**SITE PLAN REVIEW SHEET
ENVIRONMENTAL VARIANCE REQUEST ONLY**

CASE: SP-2017-0176D

PROJECT NAME: 1704 & 1706 Channel Road

The applicant requests the following: To allow cut above 4' within Lake Austin [25-8-341(A)]

ATTACHMENT 3
PROPOSED CONDITIONS

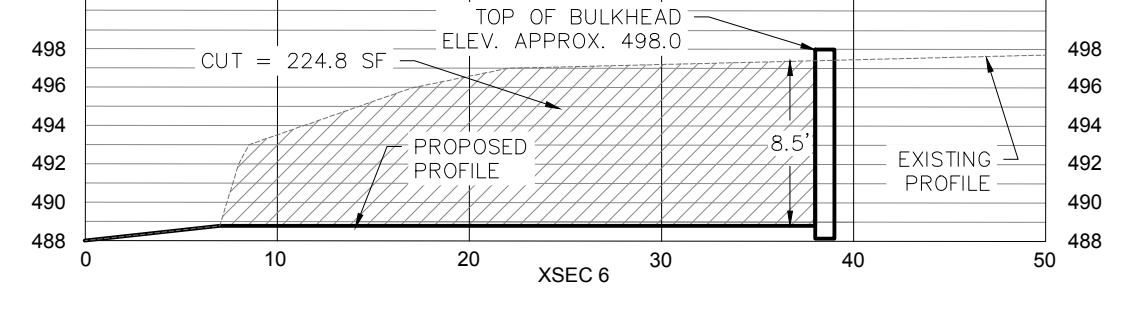
No, there is an existing cut in slip and other places along the shoreline that the boat dock could be located.

No, the development proposed is not based on a hardship but rather a preference for the boat dock location.

No, there is an existing cut in slip and other places along the shoreline that the boat dock could be located. It is unnecessary to deviate from code since other options exist.

Clearly indicate in what way the proposed project does not comply with current Code (include maps and exhibits)	<i>Enlarging the cut-in slip will require cut more than 4 ft. Attachment 3, Proposed Conditions, shows the cross-sections detailing the cut across the proposed cut-in slip. In order for a boat dock to house a ski boat and boat lift, it's necessary to have 3.5 ft of depth to accommodate the draft of the ski boat and cradle of the boat lift. The slip will extend into what is now land which is about 4 ft higher than the water surface elevation; so the depth of the cut is the sum of the height difference between the land elevation and the water surface elevation plus 3.5 ft. for the boat draft.</i>
---	---

YES. This design “provides greater overall environmental protection than is achievable without the variance”. It provides a rare opportunity for the COA to enlarge both the volume and surface area of Lake Austin by increasing the size of the cut-in slip. Doing so leads to an improved lake ecosystem while maximizing the storage capacity of the lake. The variance is required to enlarge the size of the cut-in slip and realize the benefits described above.

YES. After receiving the first set of comments in the update process and meeting with COA staff, the project design was changed to comply with a staff recommendation to incorporate the existing cut-in slip in the location of the proposed boat dock on the channel. According to staff, doing so will “avoid an environmental variance that might not meet the Findings of Fact.” The recommendation and subsequent design change requires one variance.

YES. This new boat dock incorporates the existing cut-in slip. Alternatively, a new dock could be constructed at another location and the cut-in slip could be filled so that the owners are allowed “a reasonable, economic use of the entirety of the property” (emphasis added). Filling in the cut-in slip to facilitate “use of the entirety of the property” would involve at least three variances (Fill in the Lake, Fill more than 4 ft., and Land Capture). City staff recommended against this route. The boat dock location is the location recommended by City staff, and it requires one variance for Cut over 4ft. This design is the minimum deviation from the Code.
